ADDENDUM NO. 1 TO PROJECT 45133

**CONSTRUCTION WORK, HVAC WORK, PLUMBING WORK AND ELECTRICAL WORK
REMOVE AND REPLACE COOLING TOWERS
HUGHES STATE OFFICE BUILDING
333 EAST WASHINGTON STREET
SYRACUSE, N.Y**

September 11, 2015

PROJECT NUMBER: **45133** - E
DESIGNED BY: EGR
DRAWN BY: TLC
FIELD CHECK:
APPROVED:
SHEET TITLE: **ELECTRICAL ONE-LINE DIAGRAM & WIRING DIAGRAMS**
DRAWING NUMBER: **E-601**
SHEET 24 of 24

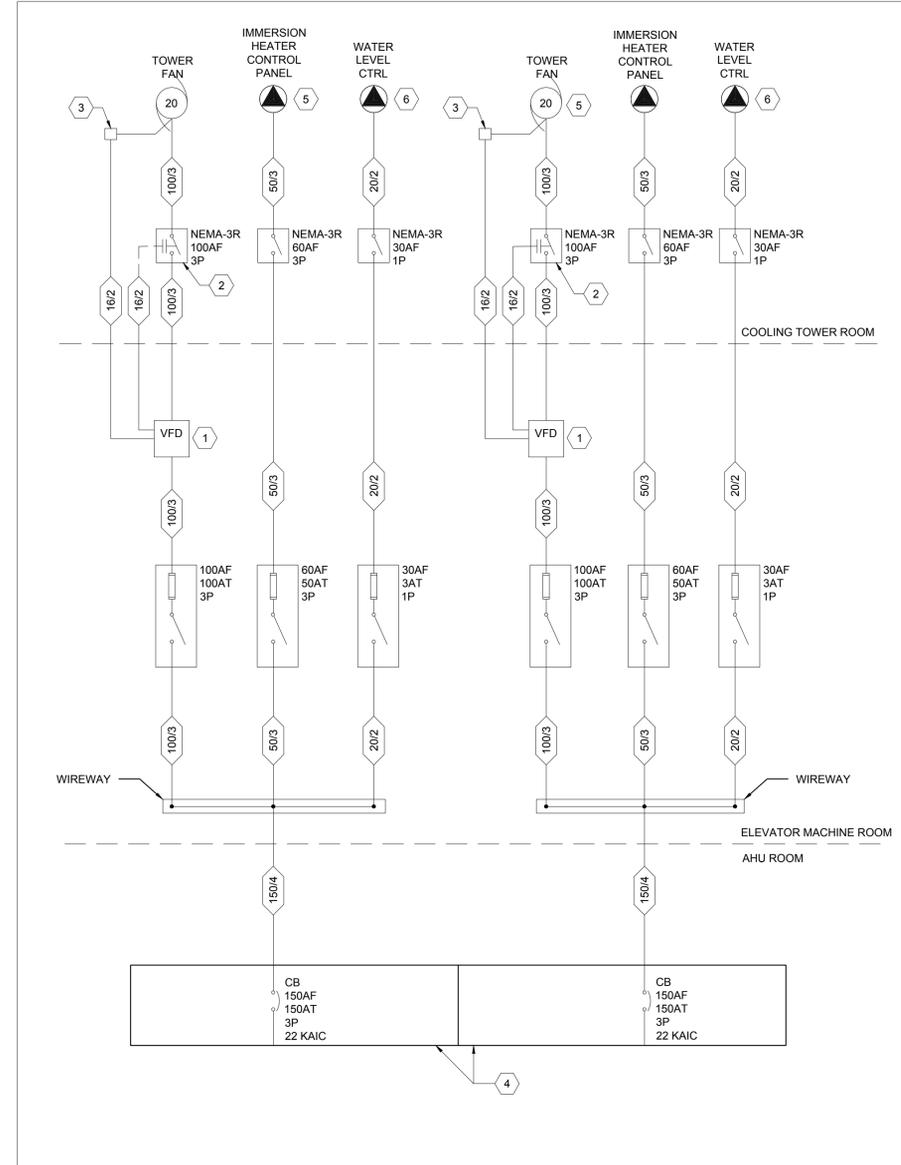
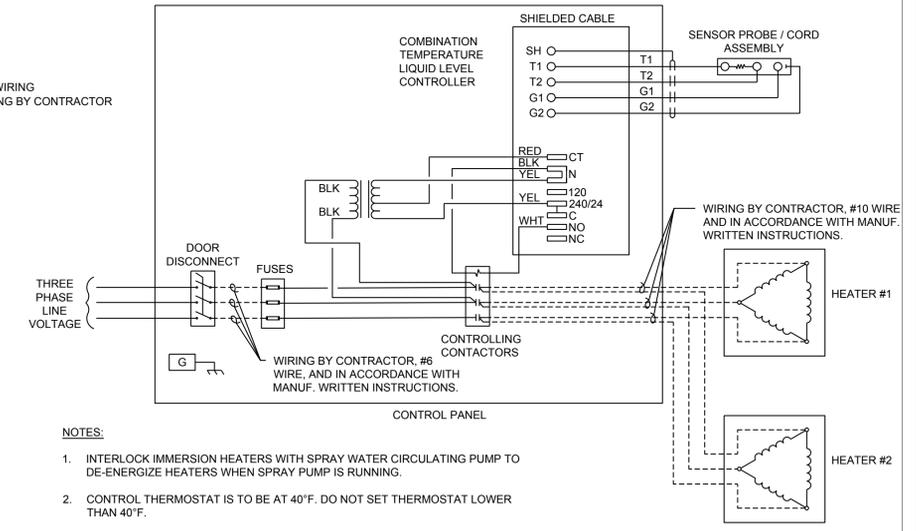
2. Revised Drawing:
 - a. Drawing No. E-601, noted "REVISED DRAWING 9/11/2015" accompanies this Addendum and supersedes the same numbered originally issued drawings.

DRAWING NUMBER: M-601

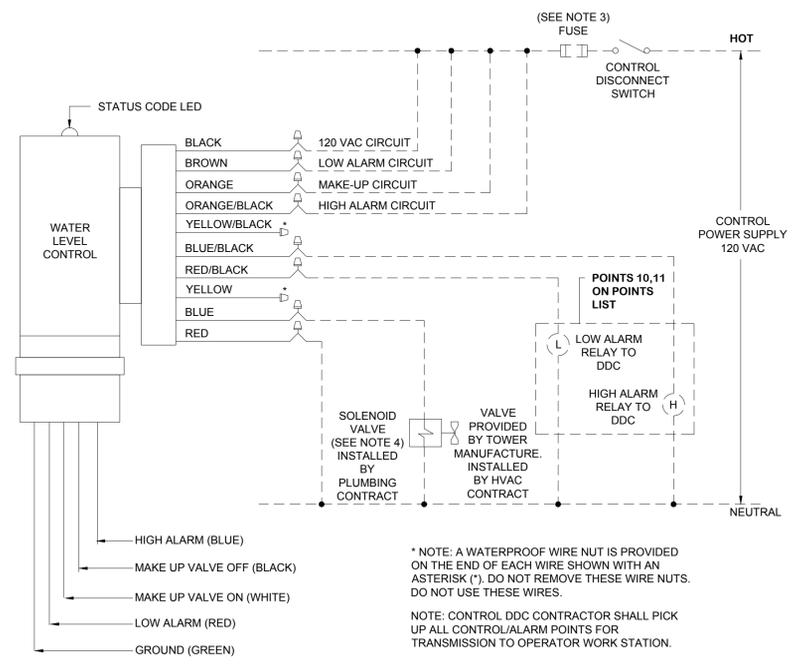
1. Addendum Drawing:
 - a. Drawing No. M-601, noted "ADDENDUM DRAWING 9/11/2015" accompanies this Addendum and forms part of the Contract Documents
